RECEIPT DATE: 5/12/15 **ONSITE SEWAGE DISPOSAL SYSTEM** P 556457

PROPERTY ADDRESS: 2508 Goose Chase Way

RE: BAT Site Plan comments; 2508 Goose Chase Way (Cloverfield II, Lot 7)

SITE PLAN AND PLOT PLAN FOR BAT INSTALLATION
SPRING MILL LLC
2508 GOOSE CHASE WAY
TAX ACCOUNT NO.: 353427
LOT 7
CLOVERFIELD- SECTION II
3RD ELECTION DISTRICT • HOWARD COUNTY, MD.
TAX MAP: 15 BLOCK: 7 PARCEL: 119

SITE PLAN AND PLOT PLAN FOR BAT INSTALLATION
 SPRING MILL LLC
 2508 GOOSE CHASE WAY
 TAX ACCOUNT NO.: 353427
 LOT 7
CLOVERFIELD- SECTION II
 3RD ELECTION DISTRICT * HOWARD COUNTY, MD.
 TAX MAP: 15 BLOCK: 7 PARCEL: 119

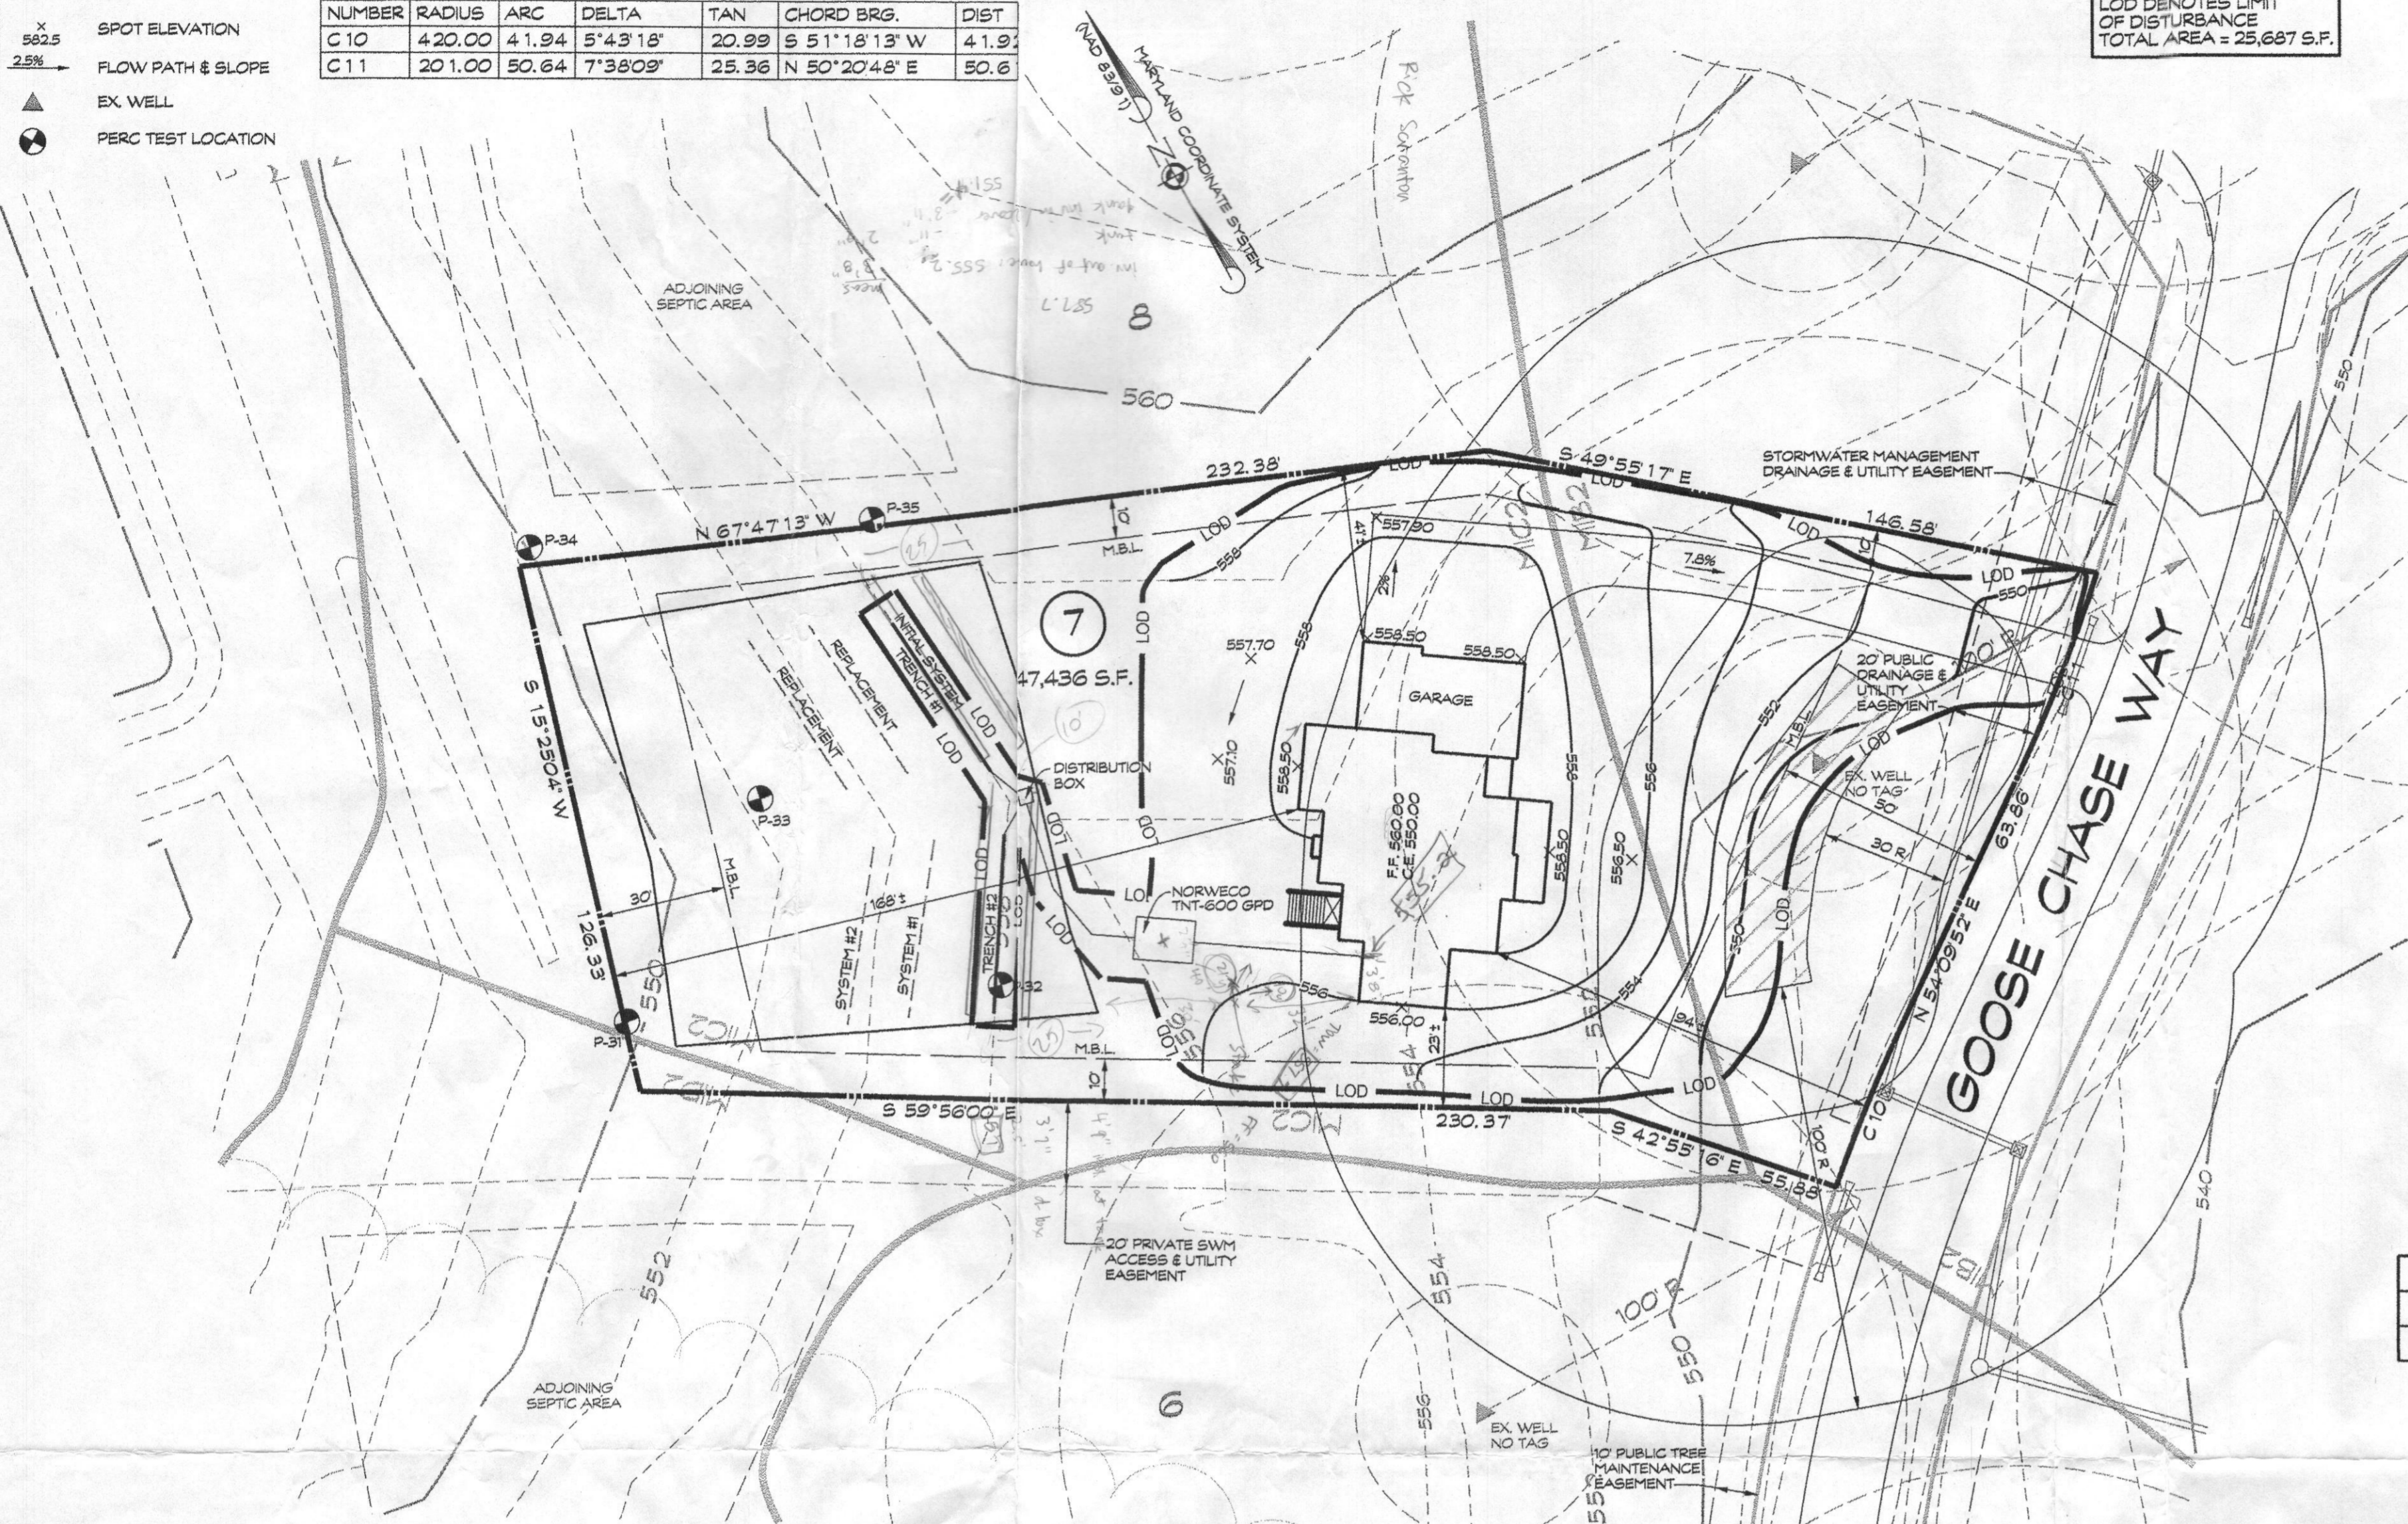
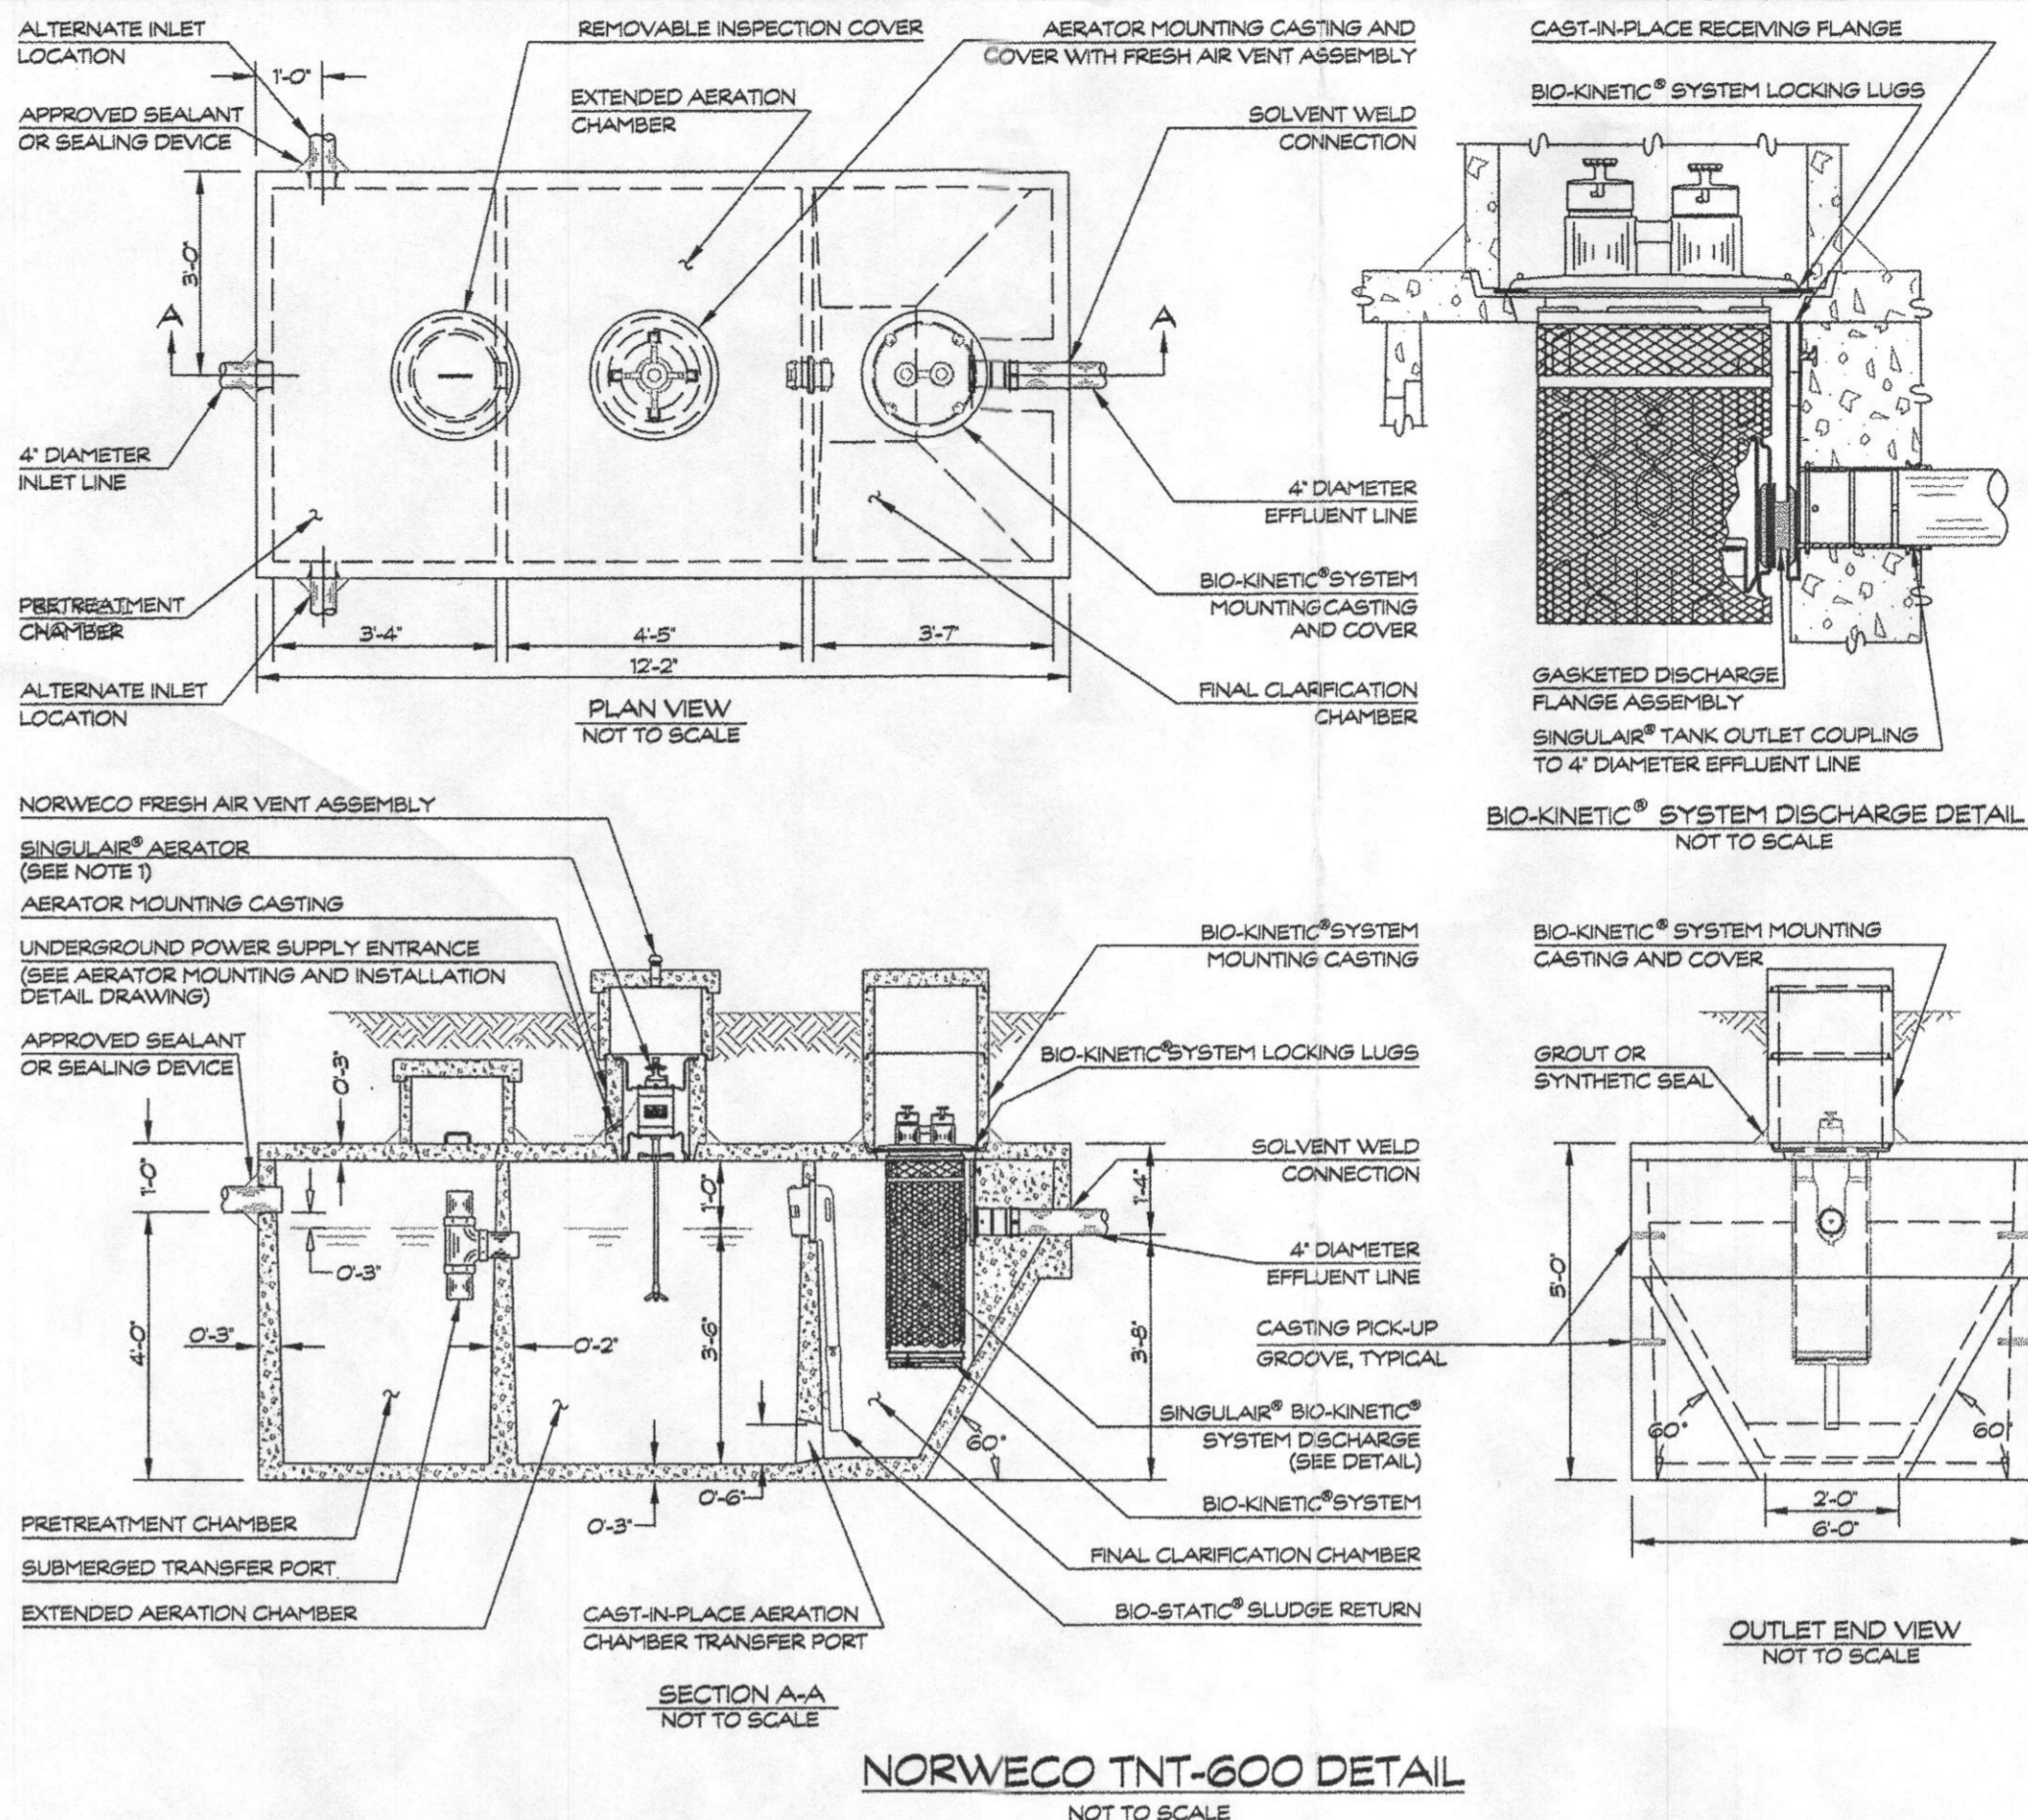
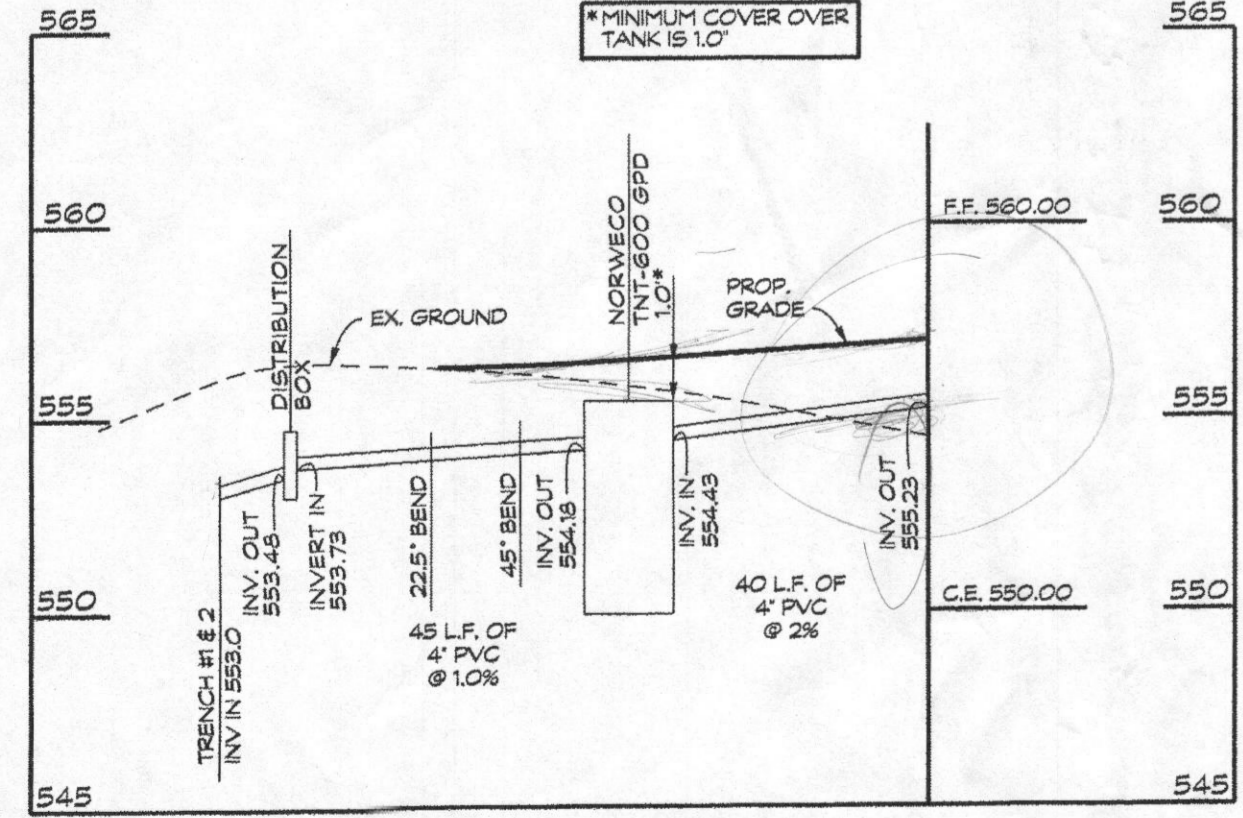
2. THE MAXIMUM DEPTH OF THE BAT PER THE MANUFACTURERS SPECIFICATION IS 4 FEET. *3 feet NB*
3. THE BAT SYSTEM SHALL BE MAINTAINED AND OPERATED FOR THE LIFE OF THE SYSTEM.

- sewer out
 - depth of tank will determine depth of inlet part of trench

Approved Septic System Plan
 Howard County Health Department
 NORWECO TNT-600
 To Gravity Drainfield
 RBuckler 5/14/2015
 Signature Date
 B15000016
